Project	<b>IEEE 802.16 Broadband Wireless Access Working Group</b> < <a href="http://ieee802.org/16">http://ieee802.org/16</a> >	
Title	<b>Construction and Transmission of MAC PDUs for IEEE P802.16m/D4 (section 16.2.4)</b>	
Date Submitted	<b>2010-03-05</b>	
Source(s)	Yih-Guang Jan, Yang-Han Lee, Hsien-Wei Tseng, Ming-Hsueh Chuang, <i>Jheng-Yao Lin</i> <b>Tamkang University (TKU)</b>	yihjan@yahoo.com
	Youn-Tai Lee, Chun-Yen Hsu <b>Institute for Information Industry (III)</b>	lyt@nmi.iii.org.tw
	Shiann-Tsong Sheu <b>National Central University (NCU)</b>	stsheu@ce.ncu.edu.tw
	Whai-En Chen <b>National Ilan University (NIU)</b>	wechen@niu.edu.tw
Re:	IEEE 802.16 Working Group Letter Ballot #31: P802.16m/D4	
Abstract	Comments on Construction and Transmission of MAC PDUs for IEEE P802.16m/D4 (16.2.4)	
Purpose	To be discussed and adopted by TGM for IEEE P802.16m/D4.	
Notice	<i>This document does not represent the agreed views of the IEEE 802.16 Working Group or any of its subgroups. It represents only the views of the participants listed in the "Source(s)" field above. It is offered as a basis for discussion. It is not binding on the contributor(s), who reserve(s) the right to add, amend or

Figure 388—Construction of a MAC PDU for transport connections

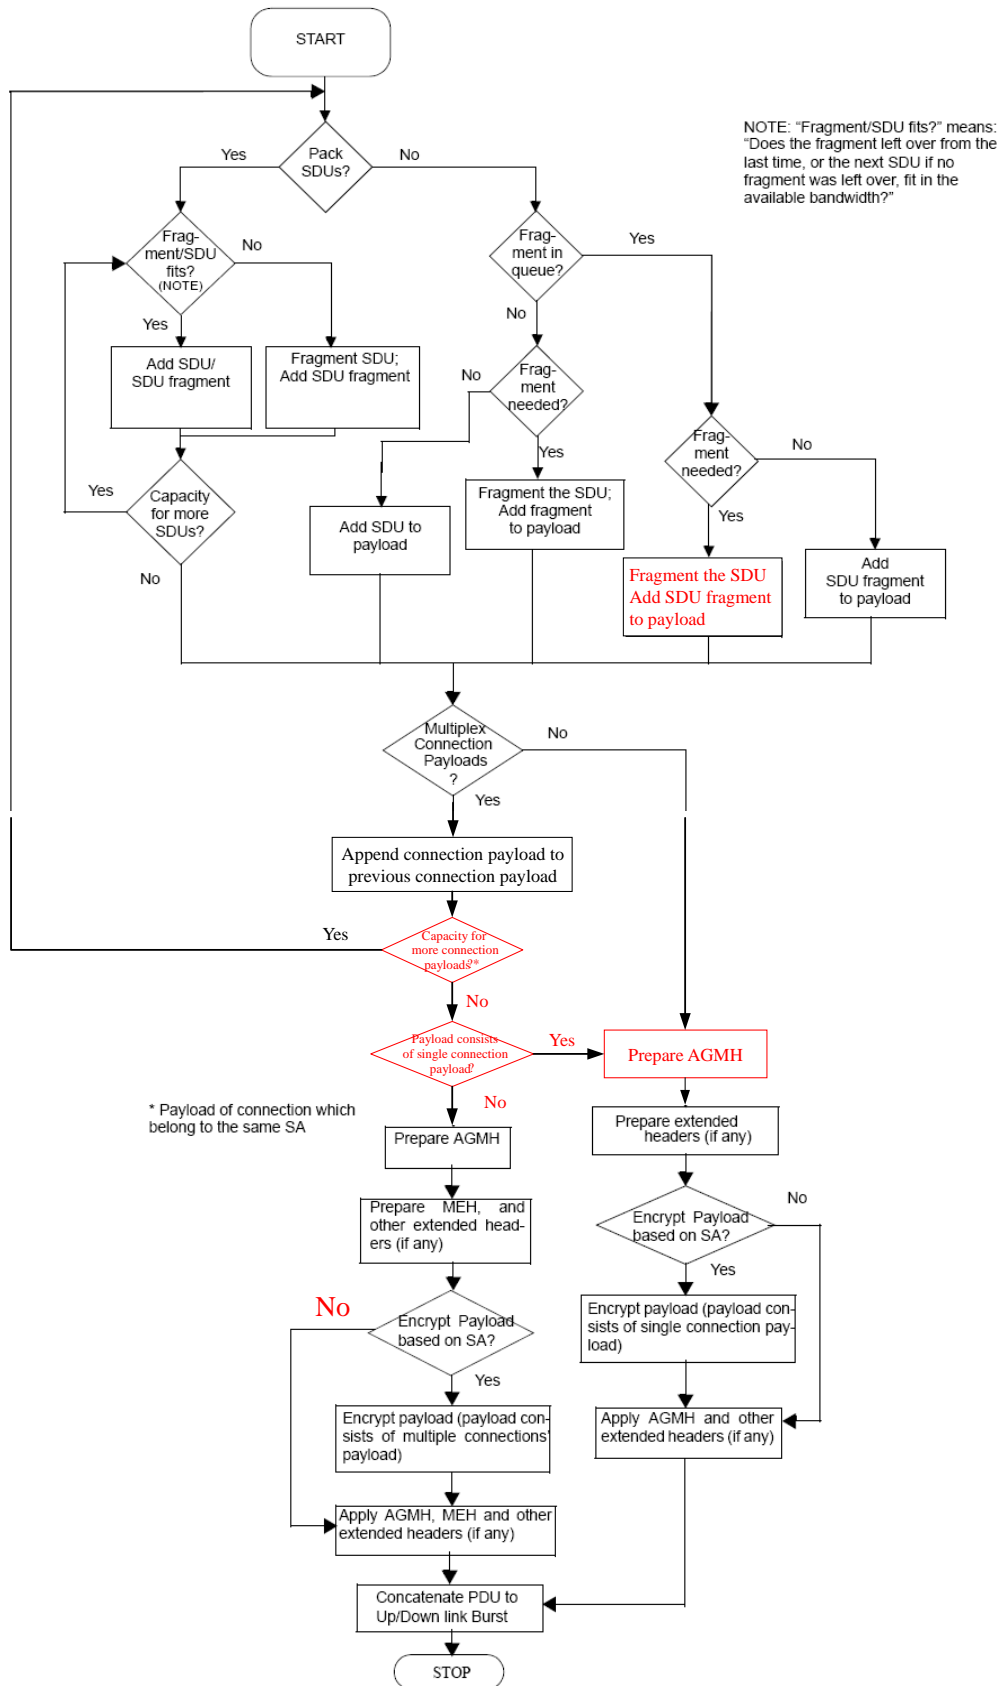
This contribution provides the corrected P802.16m/D4 text proposal to Construction and Transmission of MAC PDUs. In Figure 388, have some errors and correct the Table.

*[In IEEE P80216m/D4, Section 16.2.4, replace Figure 388 by the following corrected Figure]*
